**Agenda**  
**City of Springboro Planning Commission Meeting**  
**Wednesday, August 20, 2025, 6:00 p.m.**  
**Council Chambers, City Building, 320 West Central Avenue**

**Final Development Plan, 605 North Main Street, Easton Farm PUD-MU, Planned Unit Development-Mixed Use, multi-family residential component**

City staff recommends approval of the final development plan for the multifamily component of the Easton Farm PUD-MU contingent on addressing the following comments:

Sheet:  
**C3.0**

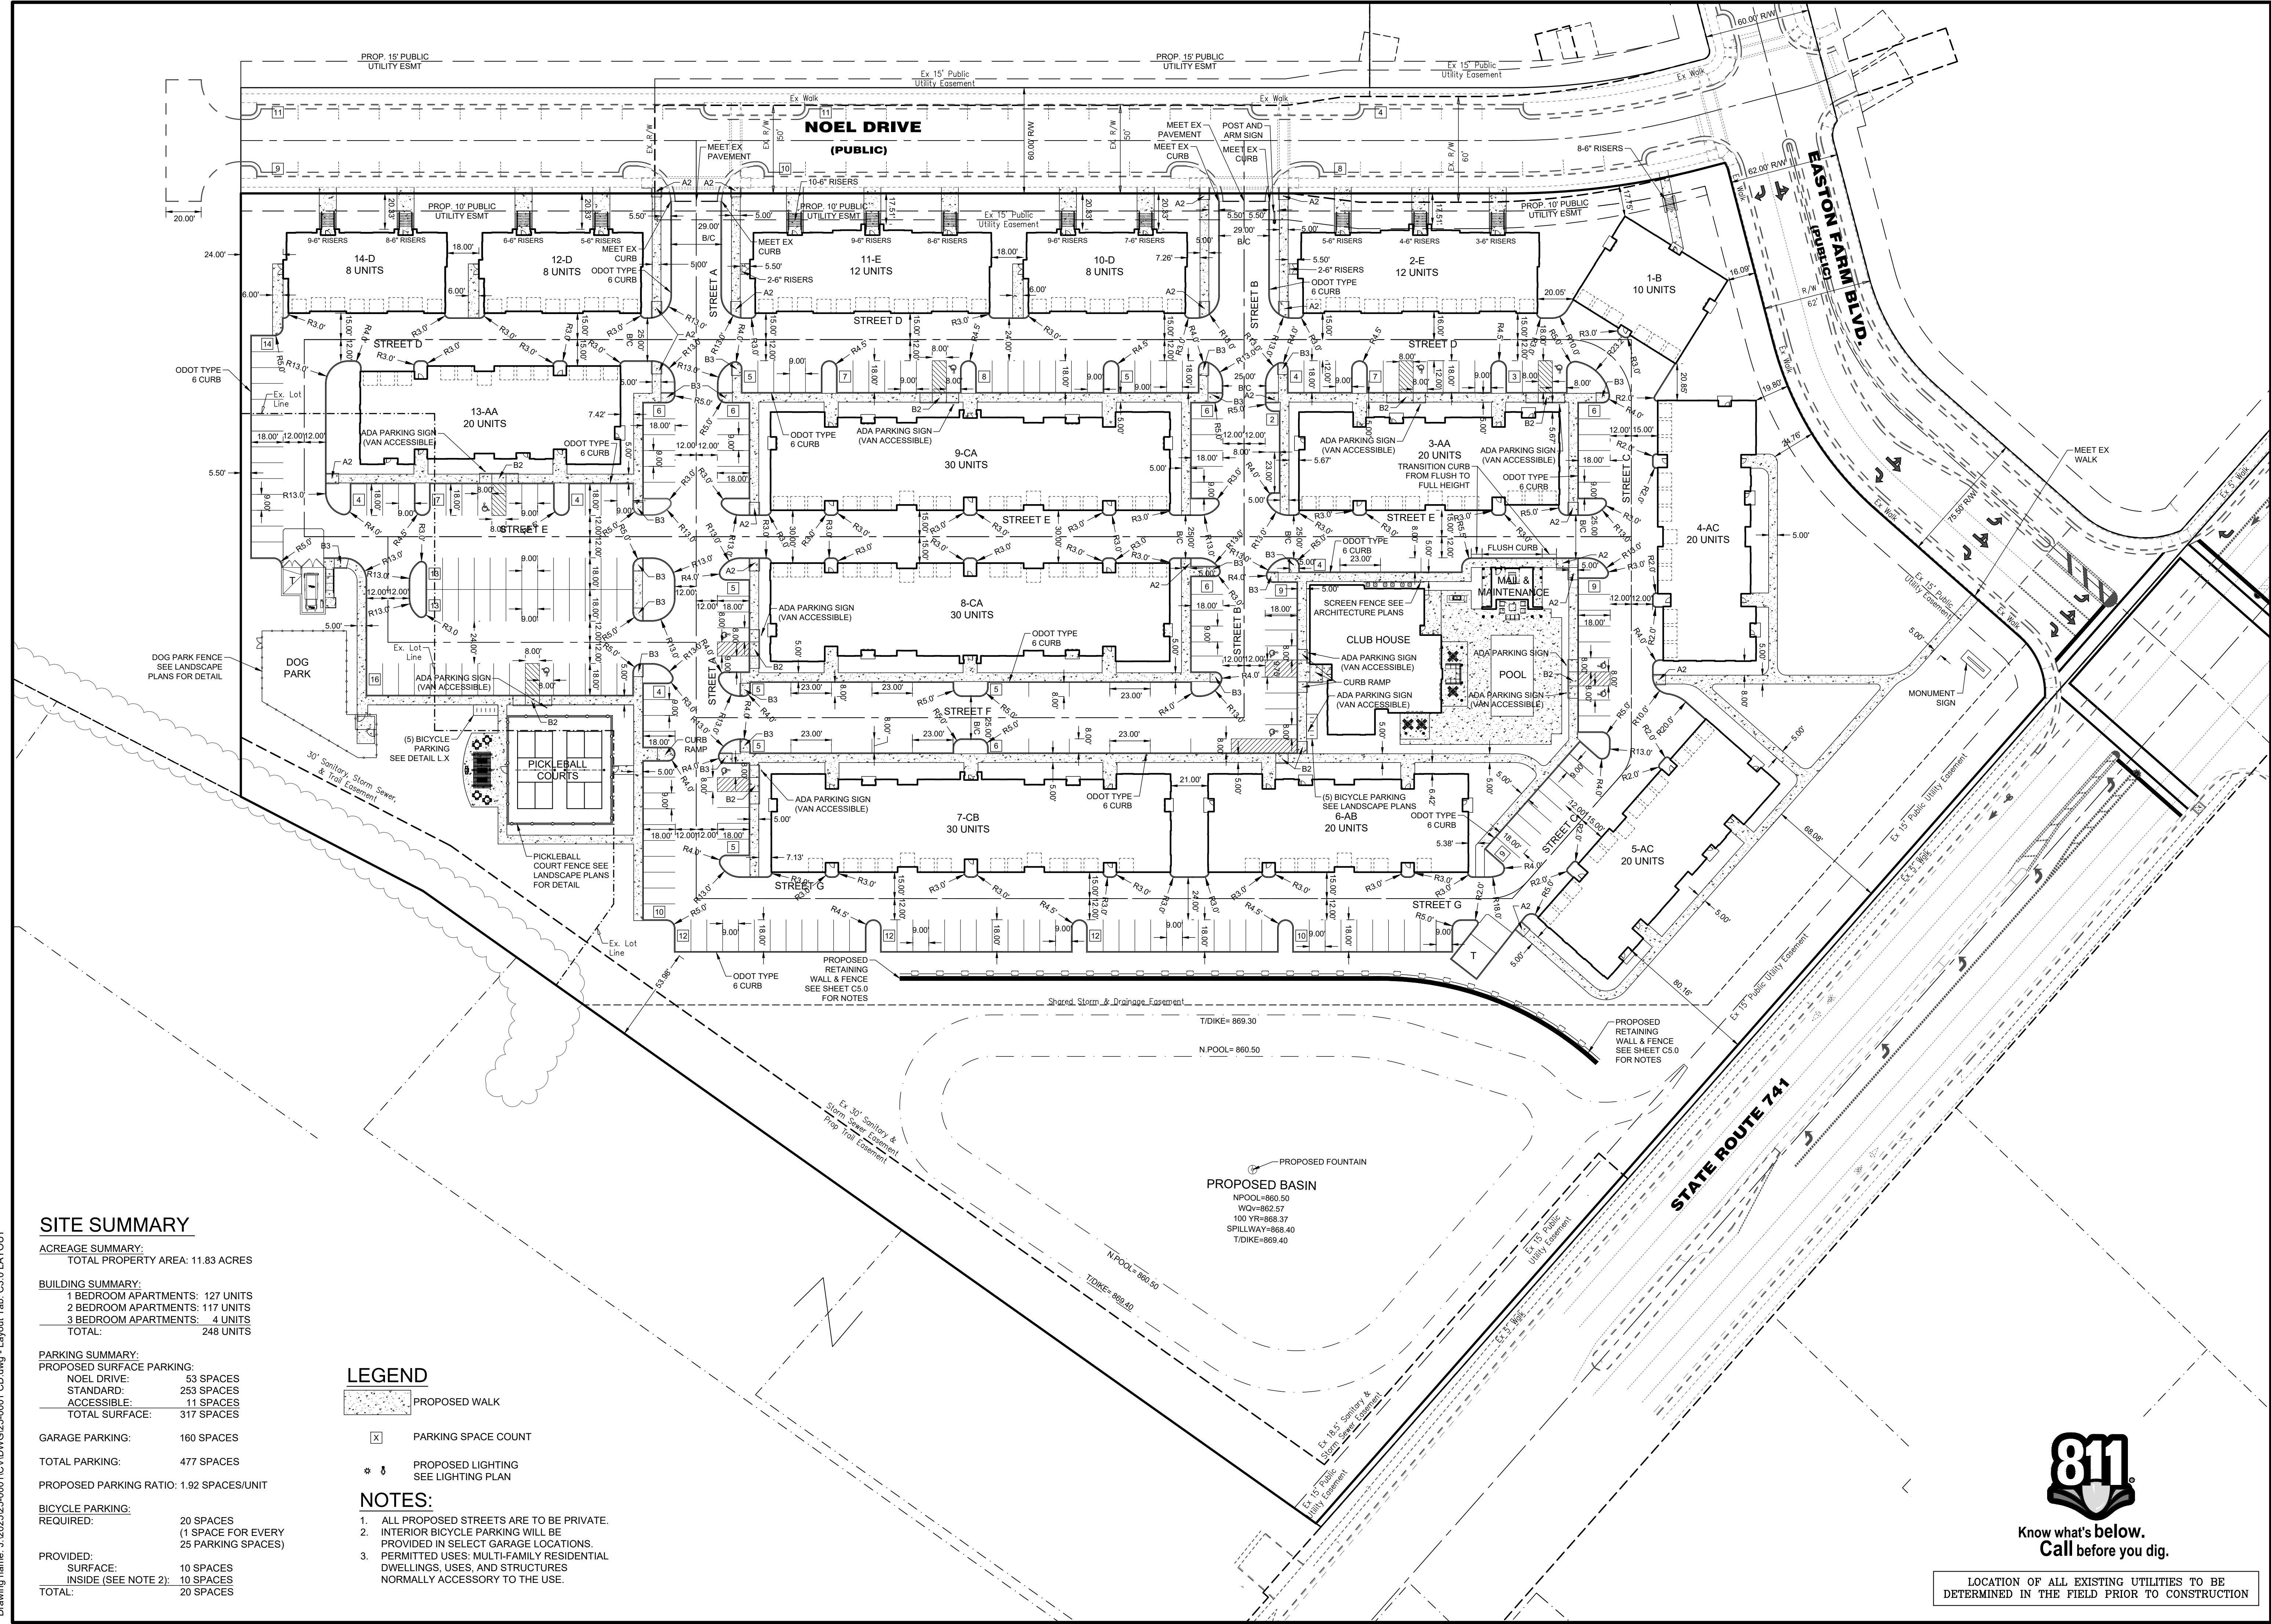
1. List permitted uses on proposed for the component: multi-family residential dwellings, uses and structures normally accessory to the use on sheet C3.0 (copy from page 3 of design manual).

- b. Page 3, per comment #1, include this information on sheet C3.0.
  - c. Page 3, use requirements table, remove or cite superscript 1 reference after Multi-Family.

**C4.0**

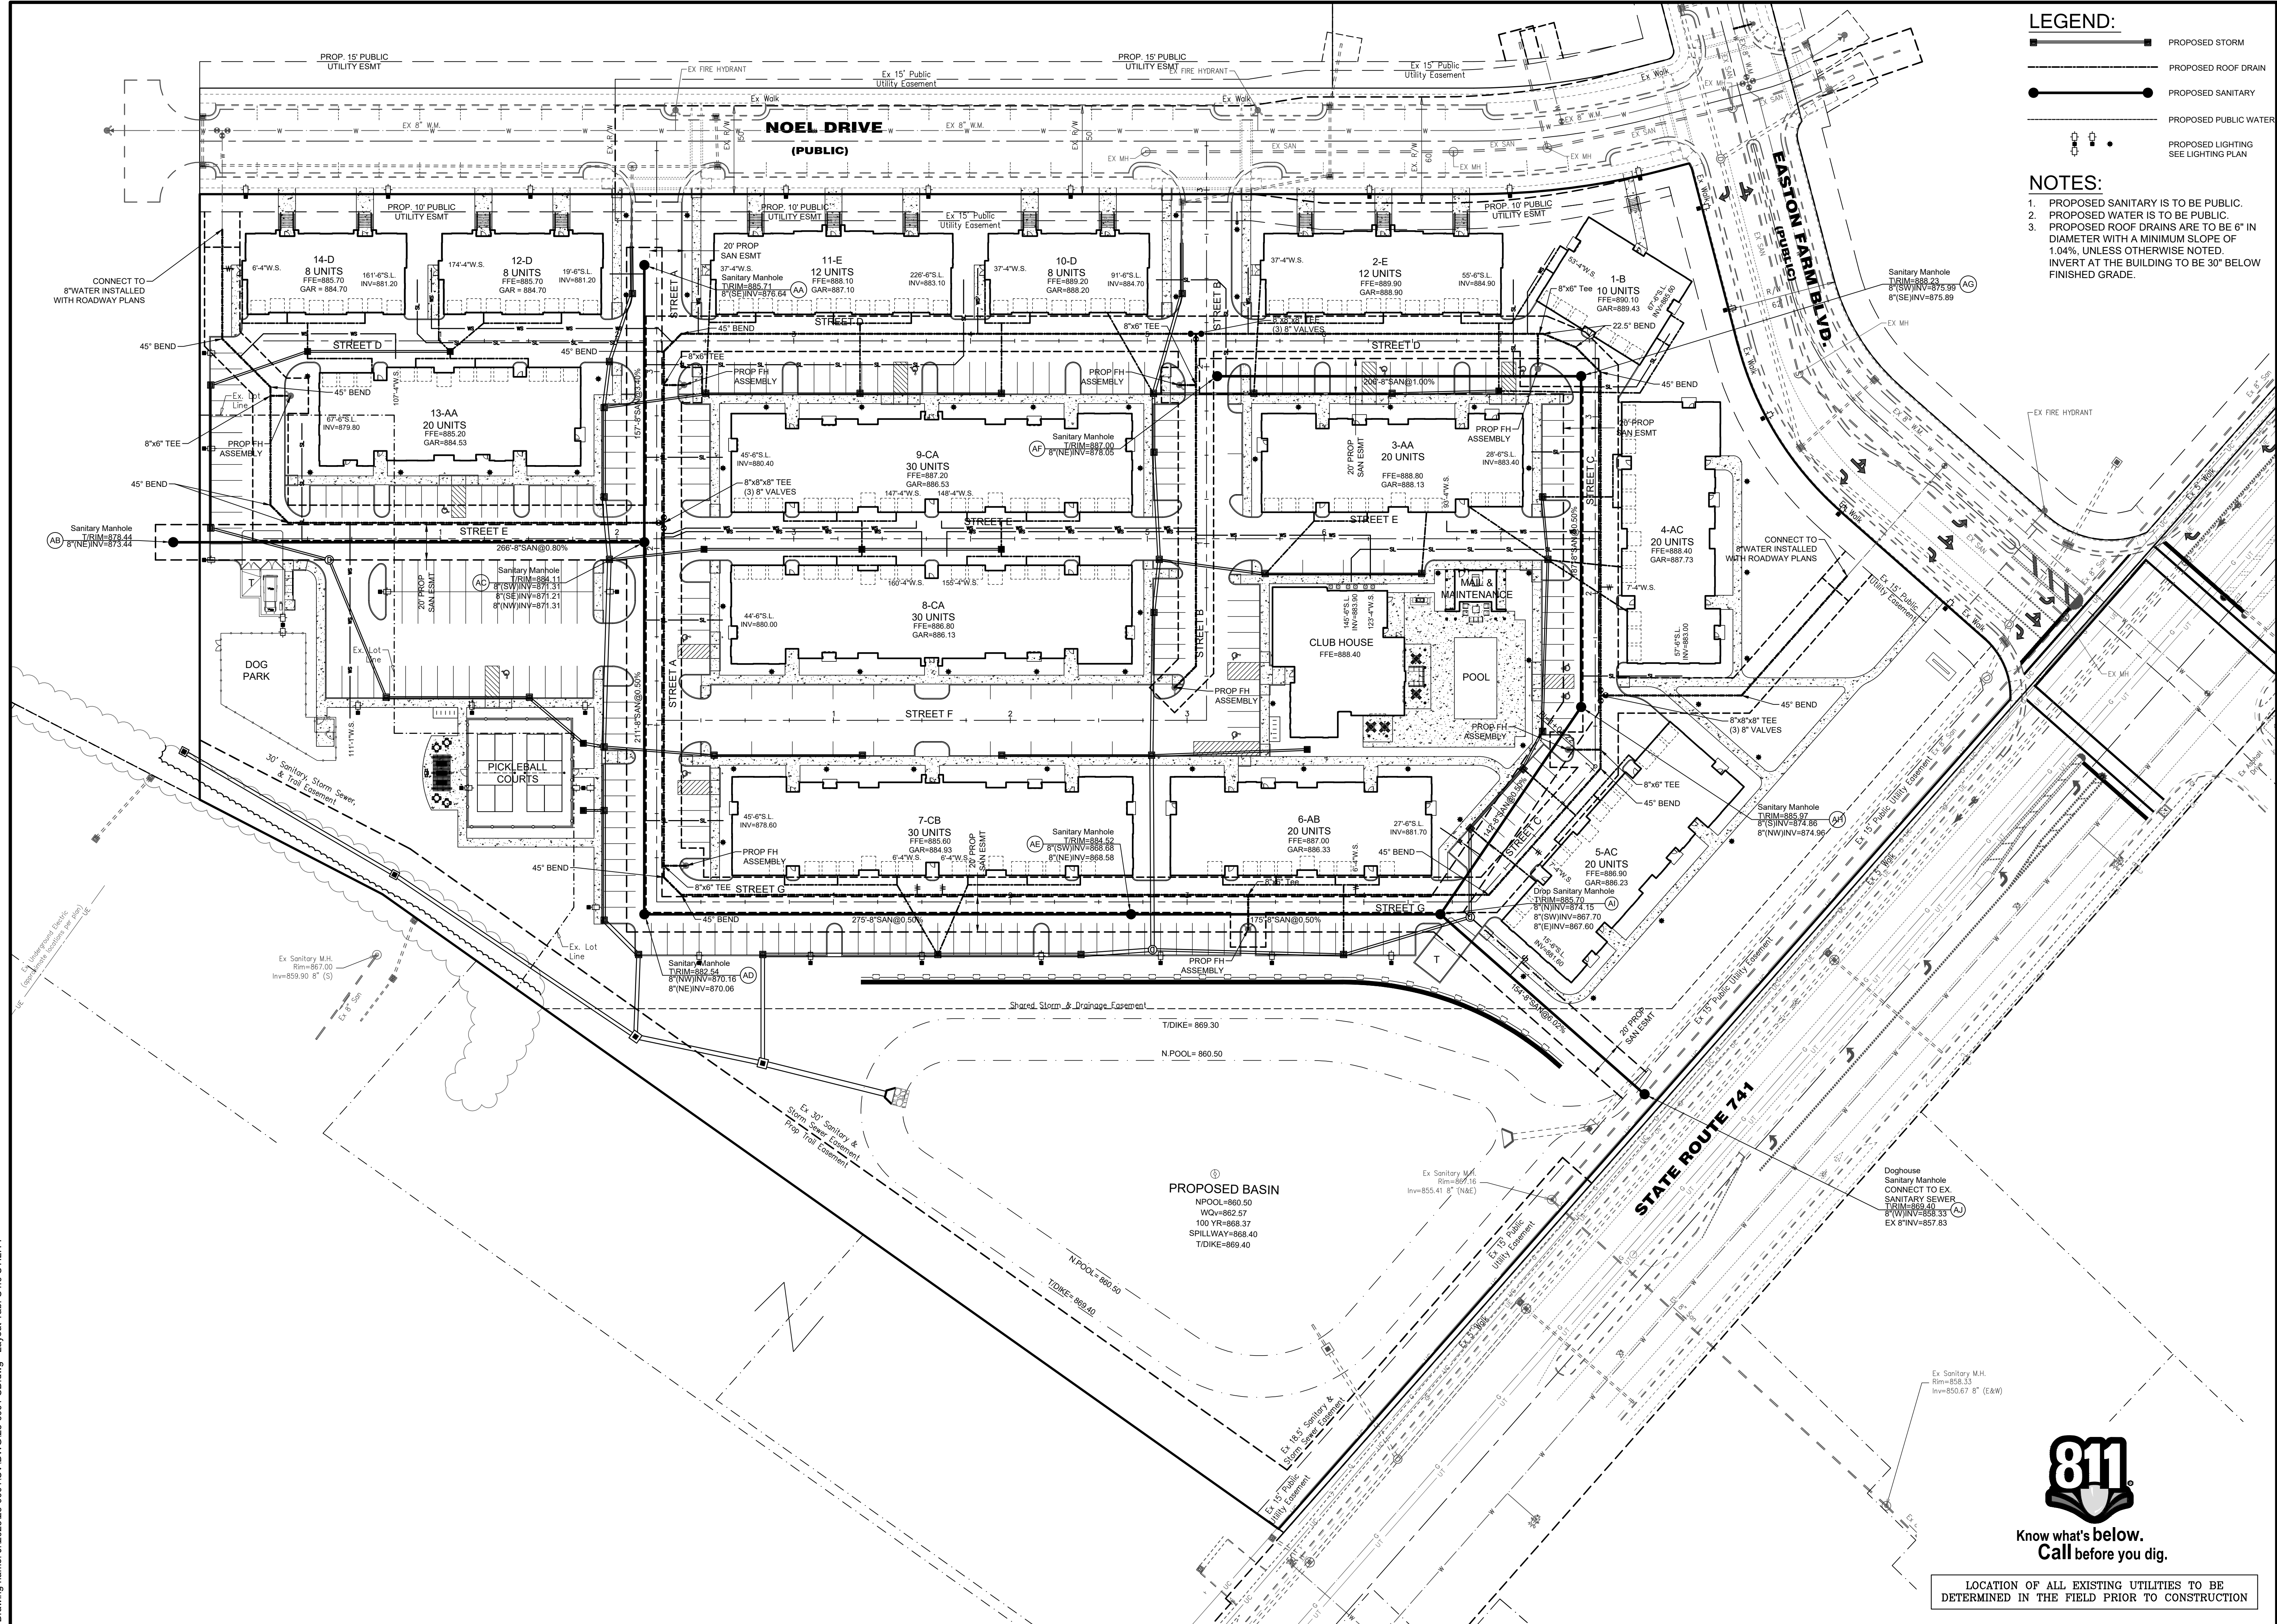
11. Provide water master meter in each building in a meter room.
12. Add a sewer span and manhole along Street A to the west of Noel Drive (120 feet at 0.5%) tying into manhole AA. Add note stating 6" sewer laterals to be SDR 35 or SCH 40 material at min 2% slope.

14. Add curb stops within three feet of water lateral tap at main line. Provide 4" water main material on plans (ductile iron pipe class 52).
15. Verify that 30-unit buildings requires two~4" water laterals.
